From: James Cox
Sent: 28 March 2019 08:00
To: Rob Smith
Subject: RE: Woodsmith Mine - Phase 8 (NYM/2018/0771/CVC) [NLP-DMS.FID262297]

Please find attached revised drawings the Production Shaft and Service Shaft buildings that reflect the on-site discussions held on 08/03 and 21/03. The revised plans reflect the following tweaks, in comparison to the those originally submitted as part of Phase 8 application:

DRAWING TITLE: Production Shaft Setting Out Elevations

DRAWING TITLE: Service Shaft Setting Out Elevations

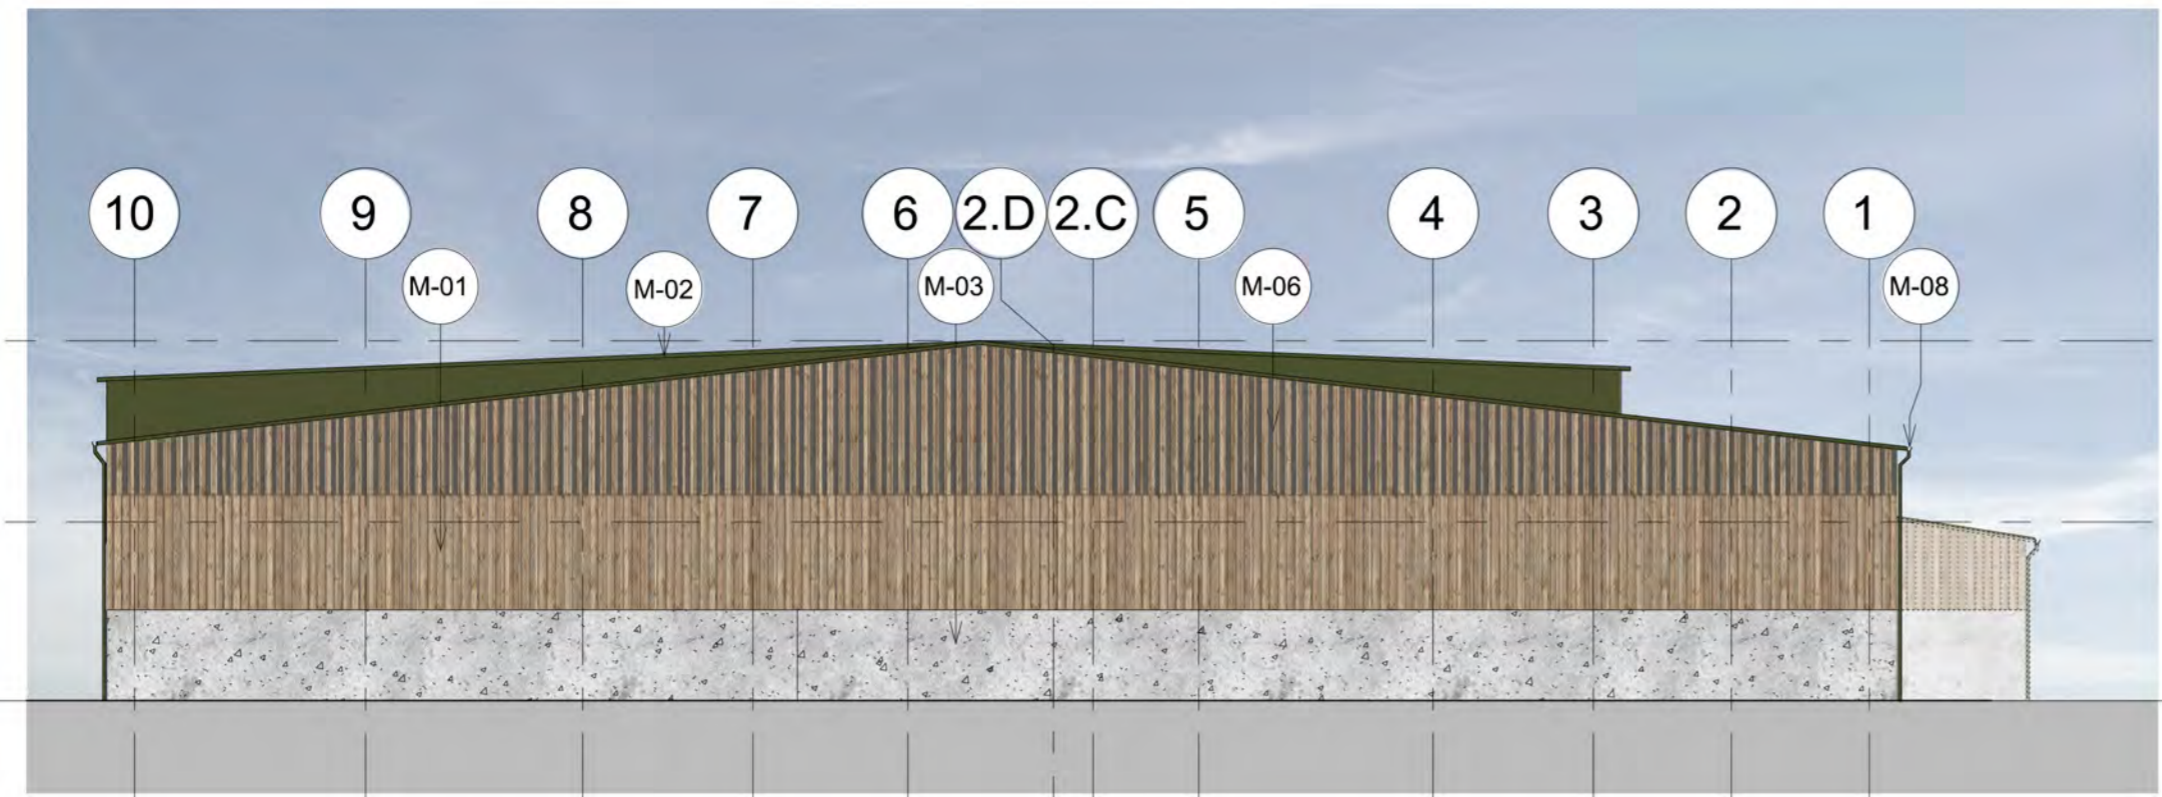
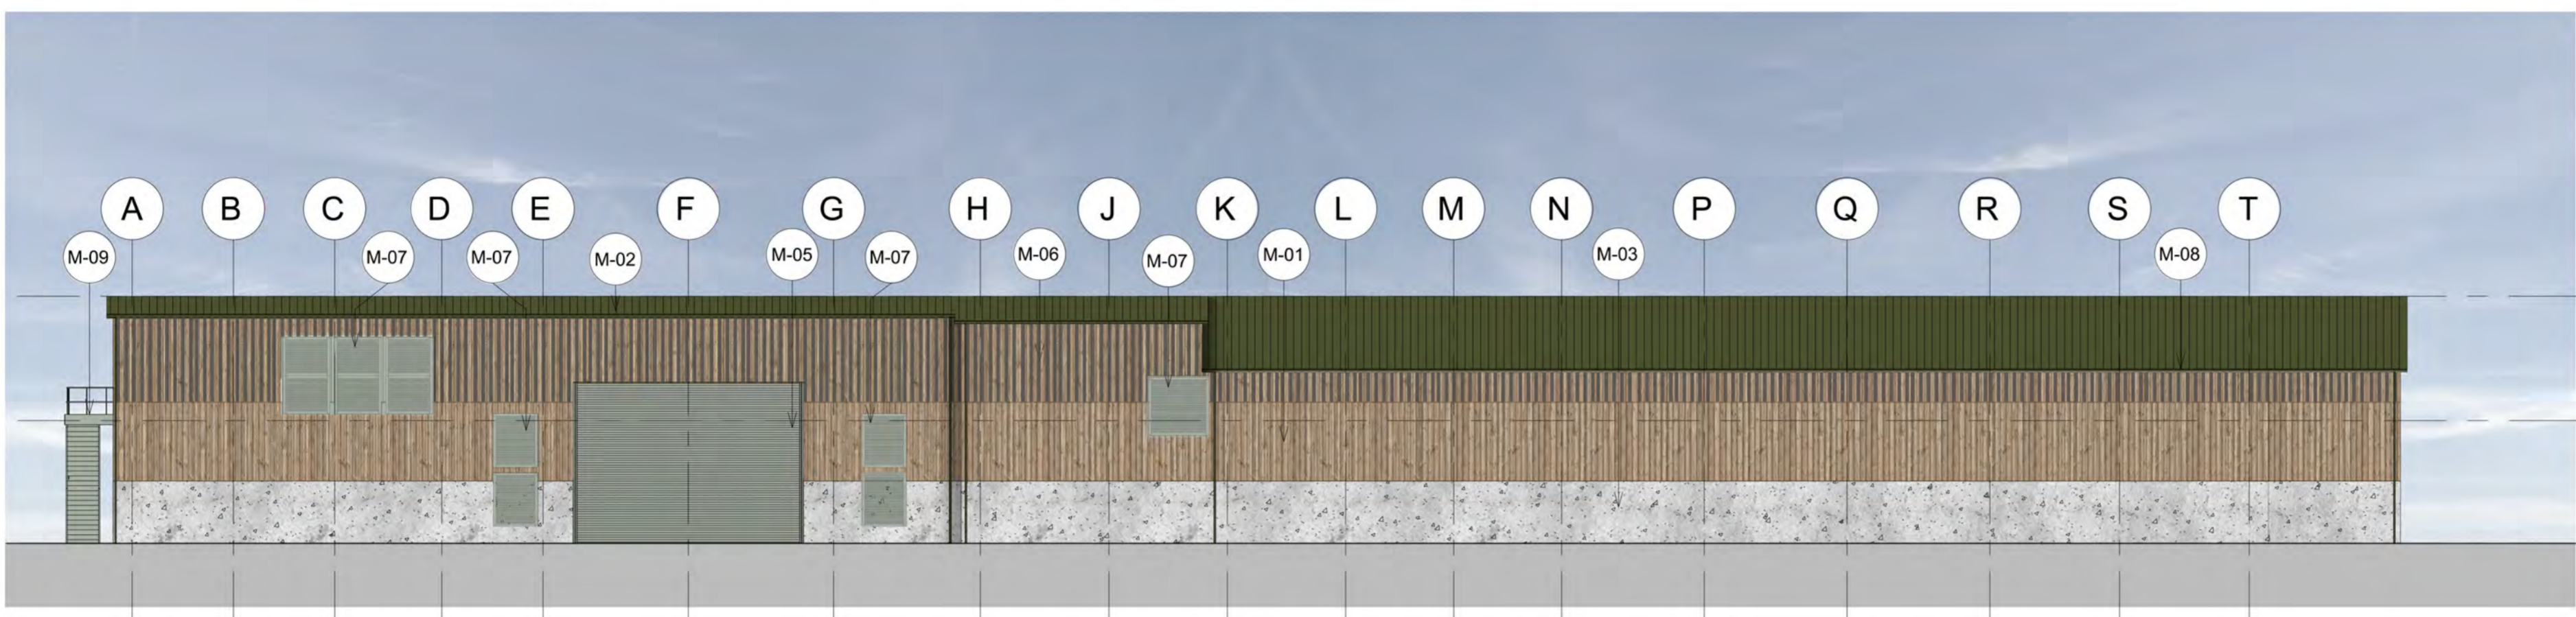
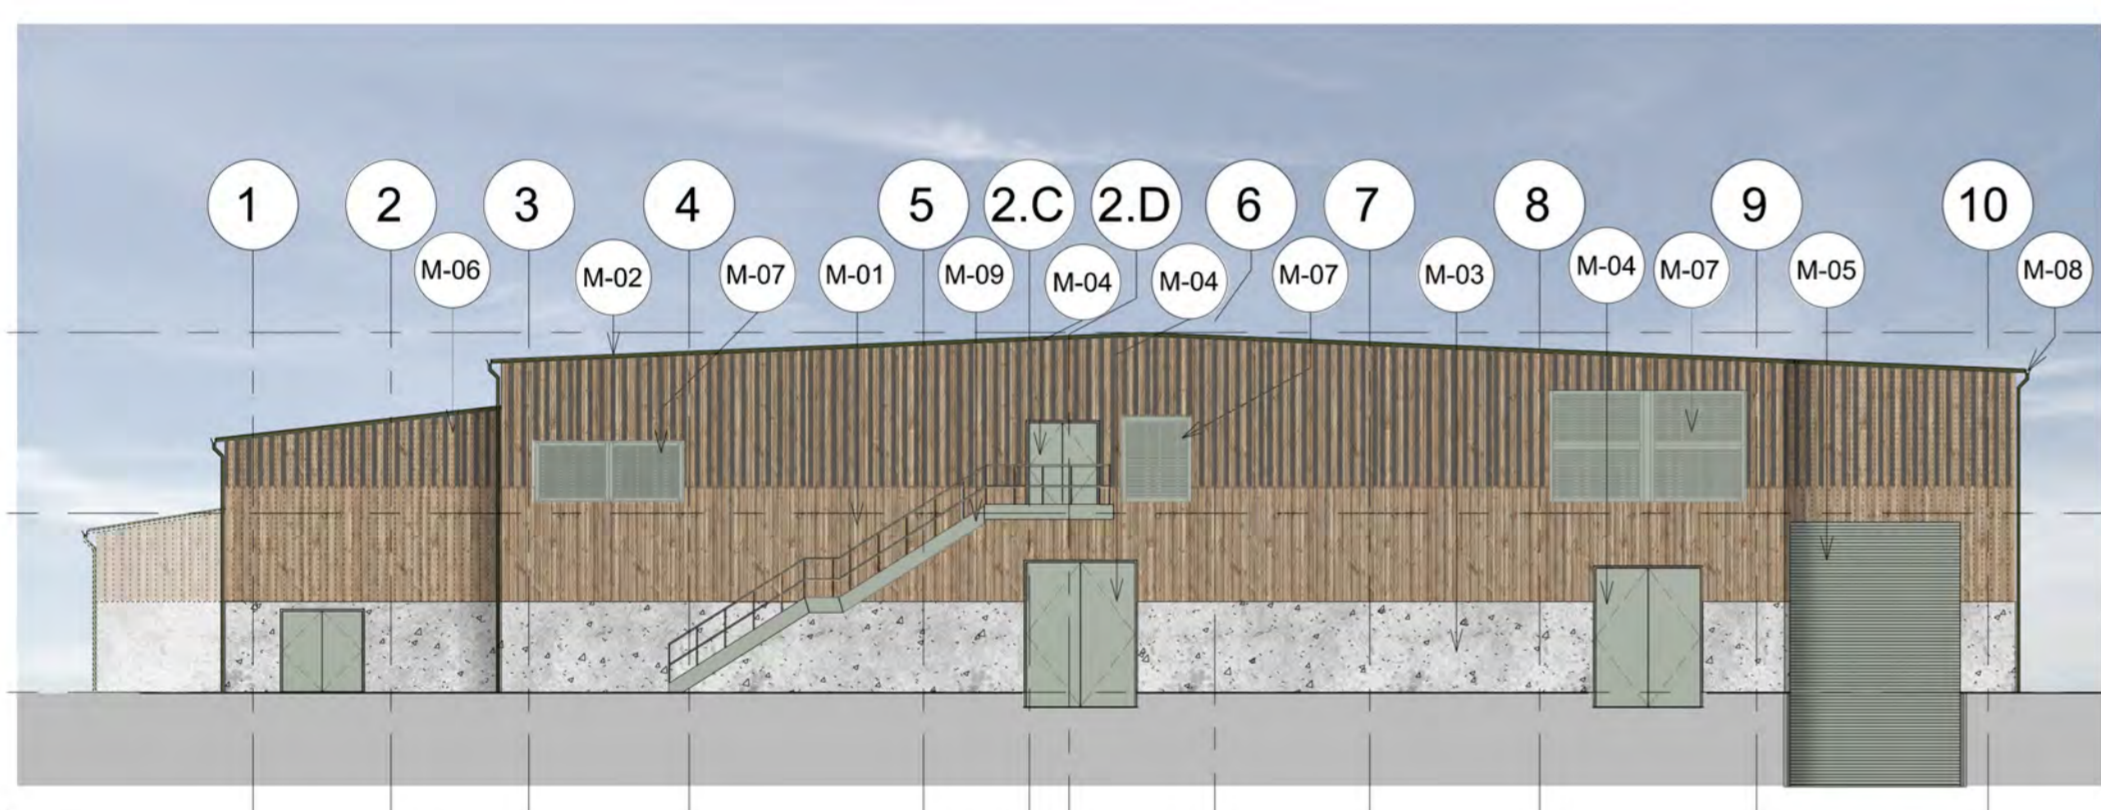
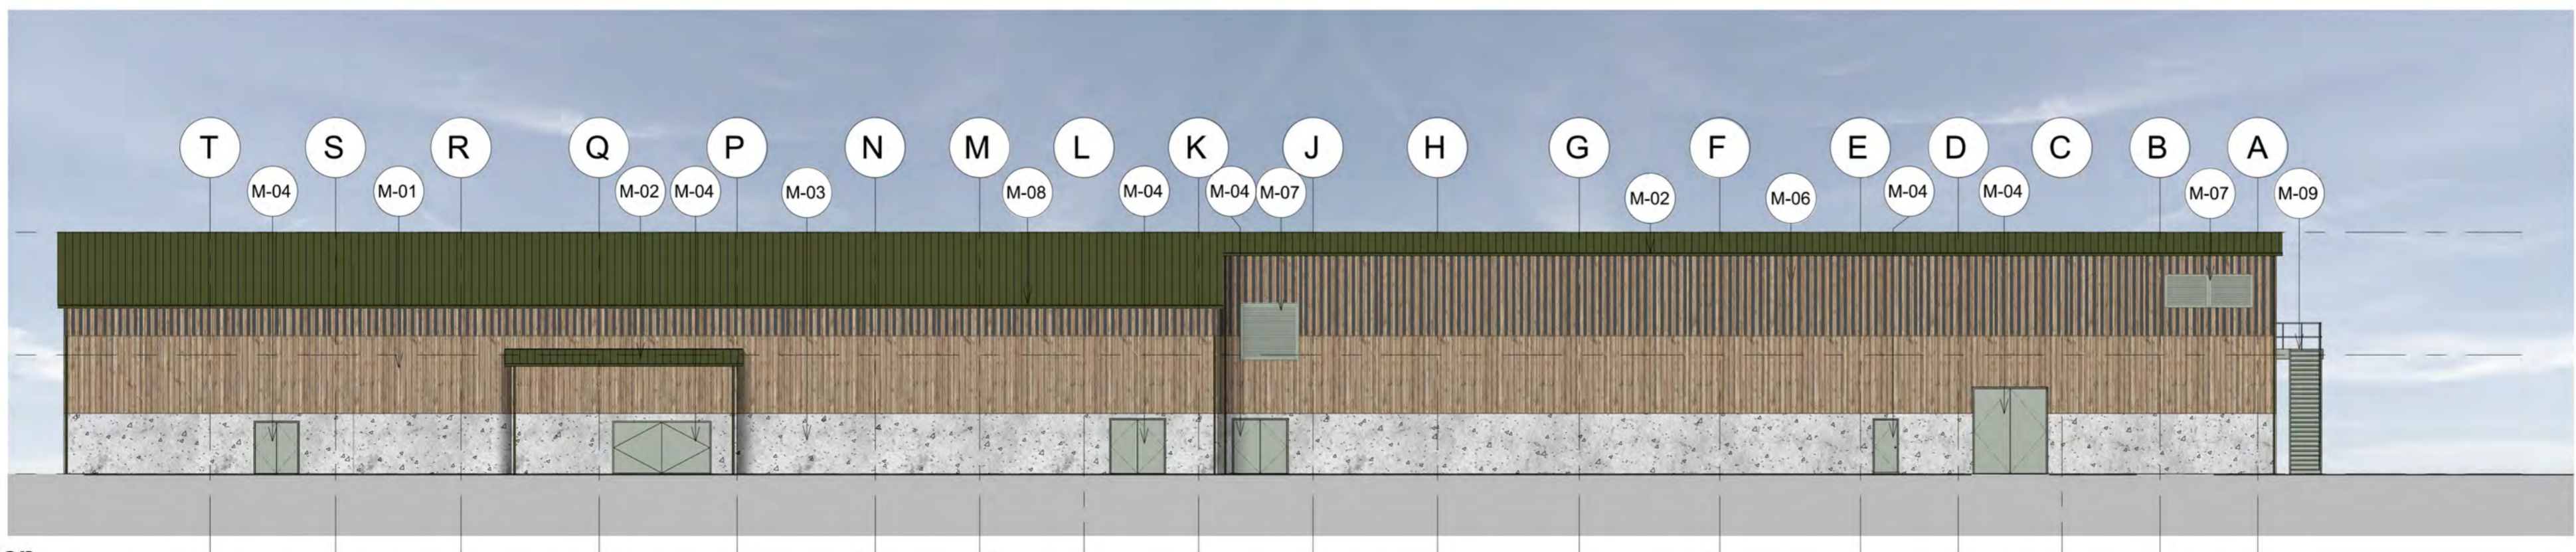
- A dark green (RAL 160 20 10) finish to the roof. This will have a non-reflective finish that will continue to dull down once it has been subjected to weather.
- Uniform wide timbers to the bottom section of the elevation;
- The retention (and slight extension) of the narrow timber board cladding to the top section of the elevation;
- Grey internal cladding;
- Light grey finishes to windows, louvres, doors etc to blend in with the natural aging of the timber; and
- A darker to the cement blocks.
